Reference: U.S. Geological Survey TRIGA Reactor (GSTR), Docket 50-274, License R-113, Email from Mr. Wertz dated September 20, 2016

Subject: Responses to email questions

USGS response to USGS Technical Specification

THE UNITED STATES GEOLOGICAL
SURVEY TRIGA RESEARCH REACTOR

Figure 1: Administrative Structure

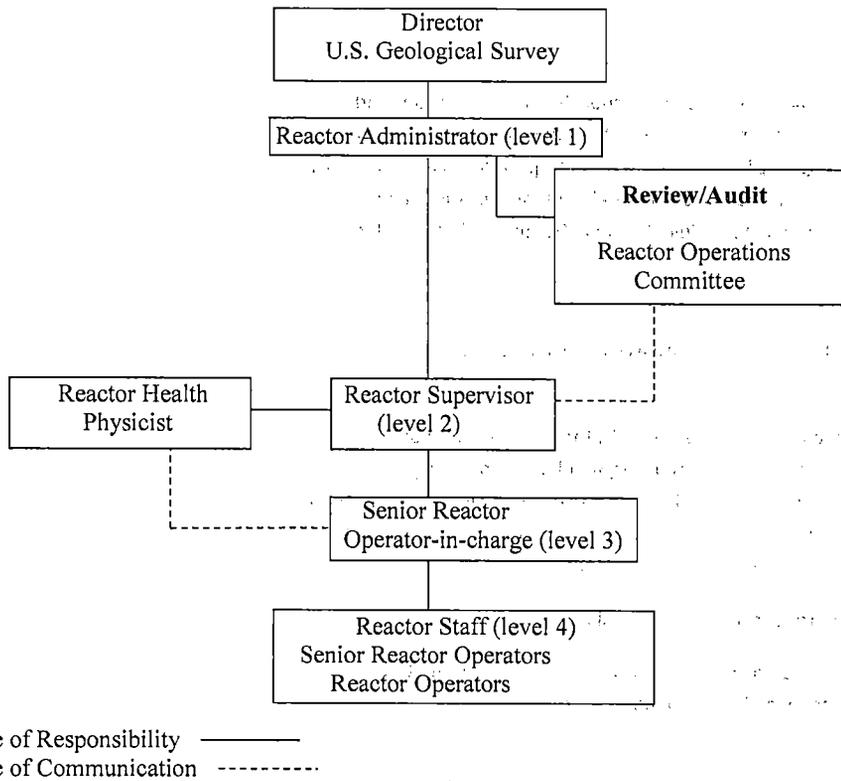
4. Response to RAI No. 33 TS 6.1.2 does not have the following sentence as stated in the RAI response.

Proposed to add the following sentences to the beginning of TS 6.1.2. "Responsibility for the safe operation of the reactor facility shall be with the chain of command established in Figure 1. Individuals at the various management levels, in addition to having responsibility for the policies and operation of the reactor facility, shall be responsible for safeguarding the public and facility personnel from undue radiation exposures and for adhering to all requirements of the operating license, the established charter, and the technical specifications.

Response: This was an oversight in making the TS edits. We agree with the above recommendation and will add the sentence as stated in the previous RAI response.
